## **FIRE RISK MANAGEMENT, INC**

# **Memo Report**

**From:** W. Mark Cummings, P.E.  
**To:** Bill Hopkins; Archetype Architects  
**Subject:** **Fire and Life Safety Evaluation of the Proposed Configuration of the Maine Wharf Museum in Portland, ME**

***Figure 1 – Proposed Maine Wharf Museum Layout***

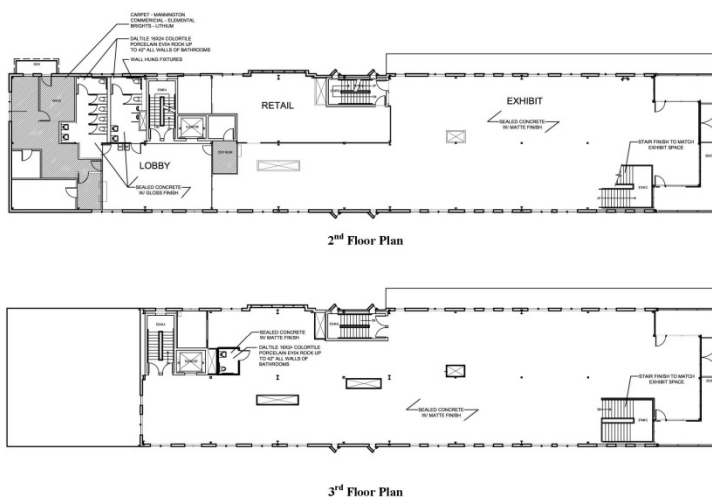
Figure 1 is a general depiction of the proposed layout for the 2<sup>nd</sup> and 3<sup>rd</sup> floors of the Maine Wharf building to accommodate the Museum space requirements. As depicted in the figure,

there is a significant amount of assembly space that is to the east of the central stair tower. Also, the location of the open stairway in the southeast corner of the building is also shown.

In general, the overall construction plan for the building will meet the code requirements of both the building code (MUBEC) and the Life Safety Code<sup>®</sup>, NFPA 101, with two notable exceptions; the use of the open stairway connecting the 2<sup>nd</sup> and 3<sup>rd</sup> floor levels, and the common path of travel restrictions within the east end of the assembly areas on both floors.

1. A smoke barrier/curtain/draft stop should be installed around the stair opening at the 2<sup>nd</sup> floor ceiling that extends to a minimum of 8 feet above the 2<sup>nd</sup> floor level. This barrier should be of non-combustible material.

2. Although used for this evaluation, based on drawings provided by Archetype Architects, the presence of the enclosure at the top of the stairway (3<sup>rd</sup> floor level) does not provide any benefit with regards to increased life safety. Unless there are other, non-fire or life safety related reasons for this enclosure, it could be removed from the building design without any impact on the level of life safety being provided.

*Figure 3 – 2<sup>nd</sup> Floor Egress Route*

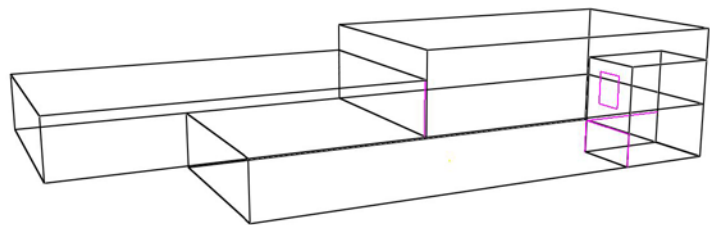
For the hazards assessment of the museum floors, the design fire is estimated as occurring at a point near the eastern exit stair enclosure; thereby potentially isolating the greatest number of occupants from direct access to a stair enclosure and requiring that they use the open stair as their initial means of egress. Figure 3 depicts both the assumed fire location and the maximum travel distance that is used to support the analysis of egress from the 2<sup>nd</sup> floor level.

are used to develop occupant load estimates. However, NFPA does not provide an occupant load factor specific to museums; only for “concentrated” or “less concentrated” assembly spaces. The most recent edition of the International Building Code (IBC) does provide an occupant load factor that is specific to museums; 30 ft<sup>2</sup>/person. Based on what has been described as the “typical” layout for the museum, the IBC value appears to be appropriate and was used when developing an overall maximum estimated occupant load for the building and its exit capacity requirements. Using this value, along with the area that is within the portion of the assembly space that is isolated from the exits by the fire, a maximum occupant load of 77 persons is estimated as being required to egress via the open stair during this fire scenario. When using the egress calculations/methods outlined in the SFPE Handbook, it is estimated that the last person will reach the top of the stairs within 90 seconds of fire notification. At that time, they are considered “isolated” from direct exposure to the smoke layer developing at the 2<sup>nd</sup> floor level. It is estimated that an additional 27 seconds would be needed for that same last individual to reach the 3<sup>rd</sup> floor exit; for a total egress time of 117 seconds.

*Figure 5 – CFAST Fire Simulation at 120 Seconds*

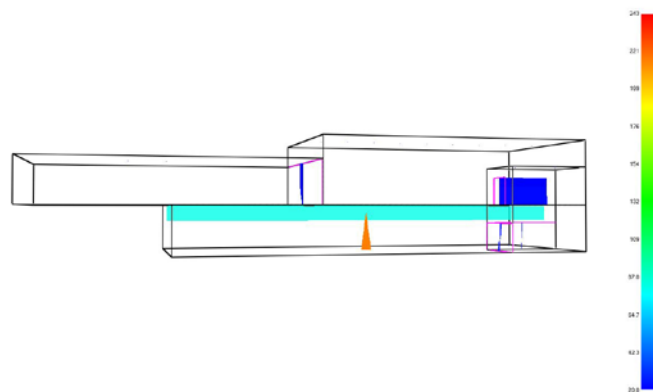
Also, there are two separate ceiling heights on the 3<sup>rd</sup> floor level, with the highest being that associated with the area below the “arched” roof. The ceiling height depicted in the model for the portion of the building that has the arched roof is a function of the “equivalent volume” for that portion of the ceiling area. The stairway is located in the southeast corner and is open to the 3<sup>rd</sup> floor above. Based on the drawings provided by Archetype at the outset of this evaluation, an enclosure is provided around the stairway at the 3<sup>rd</sup> floor level with an open doorway leading into the 3<sup>rd</sup> floor assembly space. Figure 5 is a depiction of the fire model results at 2 minutes; showing the depth of the hot upper layer at the 2<sup>nd</sup> floor level just prior to the smoke layer descending to the point that it enters the stairway opening.

**Figure 6 – 3<sup>rd</sup> Floor Egress Route**

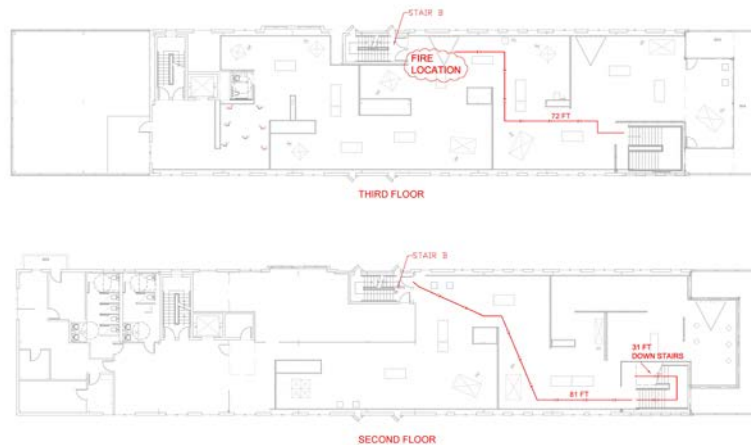
layer descends to a point that would prohibit safe egress from this floor. Figure 6 shows both the assumed fire location, which isolates the greatest number of occupants, and the route to be used by 3<sup>rd</sup> floor occupants that need to egress via the open stair to the exit located at the 2<sup>nd</sup> floor level. The occupant load estimated for the 3<sup>rd</sup> floor scenario is 76 persons. The egress analysis estimated that it would take approximately 91 seconds for all persons to exit the open stairway at the 2<sup>nd</sup> floor level and 118 seconds for the last person to reach the 2<sup>nd</sup> floor exit; values that are obviously similar to the 2<sup>nd</sup> floor fire scenario due to the similarities in floor configurations (egress routes) and occupant loads.

When applying the design fire to the 3<sup>rd</sup> floor egress scenario, the fire model estimates that it would take approximately 170 seconds for the smoke layer to reach a point 7 ft above the 3<sup>rd</sup> floor level; well after the time it is estimated that all occupants would left this floor level via the open stair. Figure 7 is a depiction of the fire model results, showing the smoke layer (using 3D depiction) prior to reaching the 7 foot level at which point it would have entered the 3<sup>rd</sup> floor stair enclosure doorway.

**Figure 8 – 2<sup>nd</sup> Floor Fire Model Results**

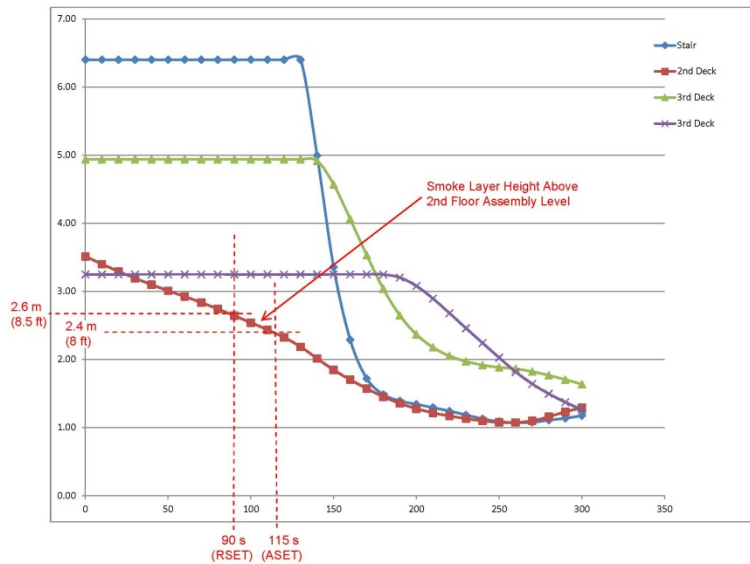
The egress analyses indicate that the required safe egress time (RSET) from both floor levels is approximately 90 seconds. The fire model results indicate that the available safe egress time (ASET) is approximately 115 seconds for the 2<sup>nd</sup> floor assembly area and 140 seconds for the 3<sup>rd</sup> floor assembly area. These data are graphically presented in Figures 8 and 9 below. The RSET value for the 2<sup>nd</sup> floor assembly is based on having the smoke barrier/curtain/draft stop installed such that it extends downward below the 2<sup>nd</sup> floor ceiling to a height of 8 ft above the finished

floor level. At this depth, a margin of safety of approximately 25 seconds is provided to ensure that all occupants are at the 3<sup>rd</sup> floor level before smoke begins to move into the open stairway. Equally, the RSET value for the 3<sup>rd</sup> floor level is also based on the smoke layer reaching a height of 8 ft above floor level; a value 2 ft greater than what is typically used in an evaluation of this type to ensure occupant safety. Even at this level, a margin of safety of nearly 1 minute is provided for the ASET value; at 149 seconds.

It is realized that the RSET value listed above is the time that it takes for occupants to safely exit the stairway on the alternate floor level and not the total time needed for all occupants to reach an exit, which is an additional 27 seconds. However, the reason for using the time to reach the alternate floor level as the RSET value is due to the fact that the time needed for the smoke level to then reach a level of 8 ft above the level of exit discharge is much longer. For example, as seen in Figure 8, the smoke layer would not reach a point 8 ft above the 3<sup>rd</sup> floor level until after

**Figure 9 – 3<sup>rd</sup> Floor Fire Model Results**

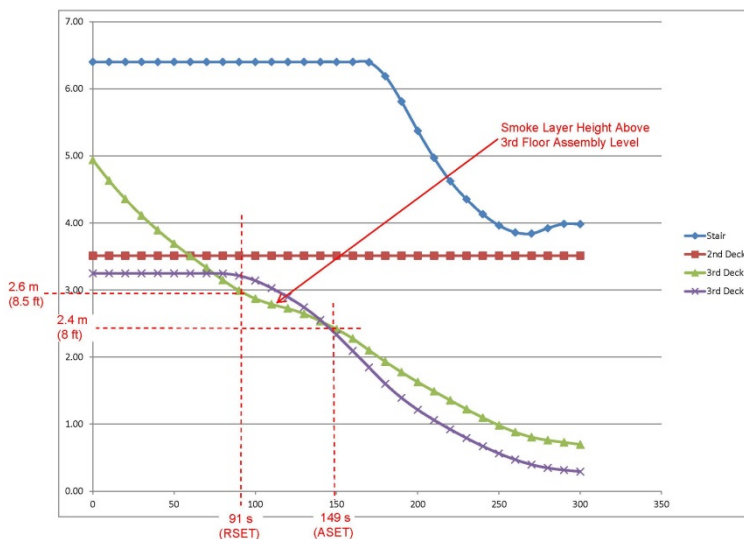
3 minutes had elapsed; and the smoke layer never descends below the 3<sup>rd</sup> floor level within the 5-minute duration of the fire simulation when the 2<sup>nd</sup> floor exit is used (Figure 9).
